SERVICE BULLETIN # 00279

SUBJECT: Incorrect Refrigerant Charge on Vender Serial Plate

MODELS: Australian RVV NG

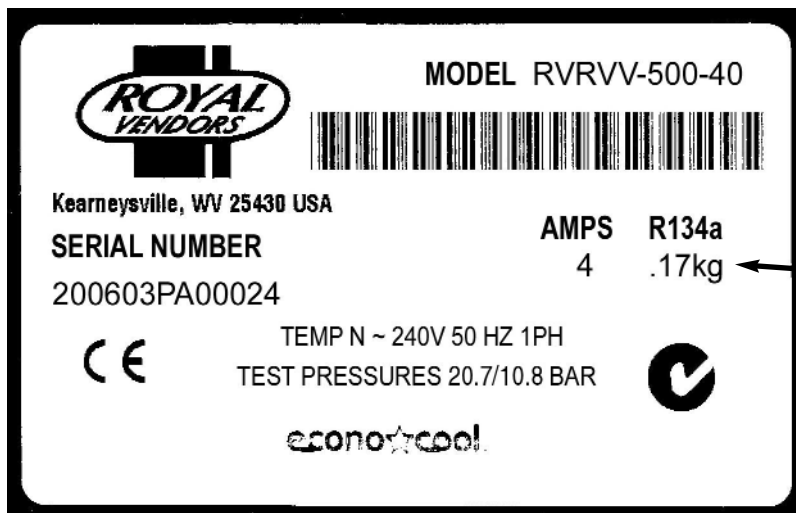
REASON FOR BULLETIN: On the vender serial plates of some RVV NG's built for export to Australia, the refrigerant charge quantity is listed incorrectly. On these units, the charge is listed as "0.17 kg" instead of the correct charge, 0.23 kg.

NOTE: There are two serial plates on the vender. One is located on the left-hand side of the door; the other is located on the kick plate of the vender's refrigeration unit. Check **BOTH** of these serial plates to ensure the correct charge is listed on them. The door serial plate is shown below.

Place replacement decal over the incorrect R134a charge listed on the serial plate.

1. Thoroughly clean the serial plate to remove all dirt, oils, etc.
2. Place the replacement decal over the incorrect charge printed on the serial plate.
